ECE/TRANS/WP.29/GRE/2008/51
11 July 2008

Proposal for Supplement 18 to the 01 series of amendments Regulation No. 6
(Direction indicators)

Submitted by the expert from France */

Minimum horizontal visibility angles

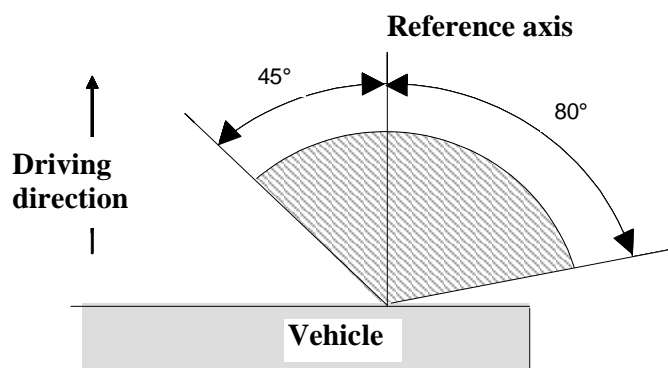
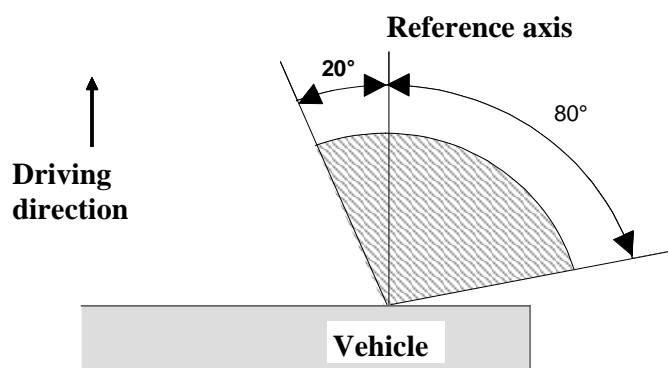
**On and above the H plane
for all lamps.
Under the H plane for
lamps intended for M₂, M₃
or N₂ category of vehicles**

**Under the H plane for
M₁ and N₁ category of
vehicles**

**H plane: "horizontal plane going
through the reference centre of
the lamp"**

The current visibility requirements of the front and rear direction indicators and position lamps were written in the early 1970s. They were easily fulfilled in those times because the shapes of the vehicles were simple and rather boxy. Recent styling trends based on better aerodynamics and pedestrian protection lead to contoured shapes making the fulfilment of the 15° down and 45° inboard (15D-45inboard) visibility requirement impossible to achieve.

The interior visibility angle reduction of the front direction indicator from 45° to 20° has a minimum impact on the distance of visibility of the vehicle when observed along its longitudinal median plan. In the case of a vehicle with 1,400 mm between the reference axis of the direction indicator lamps, this angular reduction, as seen by an observer squatting on the median longitudinal plan of the vehicle, leads to a minimal change of just 1.22 m:
